Access Compliance Report

Public Rights-of-Way

(Pedestrian Signals)

Intersection ID: N/A	Main Street:	Cross Street: N/A	Location: N/A
ADA ID: 29BB83CBF0EF	Signal Type: Two Push Buttons-Non APS	Overall Compliance: No	Severity Score: BTN 1:N/A BTN 2: N/A No BTN: N/A
Codes/Mitigation Info/Possible Solution		Field Measurements/Component Compliance

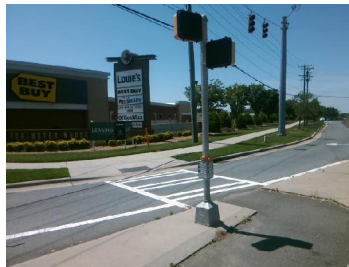
Yes	B 1 Clear Xing Direction?	ClearlyMarked	Yes	B 2 Clear Xing Direction?	ClearlyMarked
	B 1 Crossing Direction	To NE		B 2 Crossing Direction	To N
Yes	B 1 DistanceTo XWalk (in)	12.0	No	B 2 DistanceTo XWalk (in)	64.0
Yes	B 1 DistanceTo Curb (in)	29.0	Yes	B 2 DistanceTo Curb (in)	29.0
Yes	B 1 Diameter (in)	2.0	Yes	B 2 Diameter (in)	2.0

Possible Solutions: Provide Push Button Extension. Remove and Replace Clear Space. Replace Signal Push Button With APS Button on New Post. Remove & Relocate Sign.
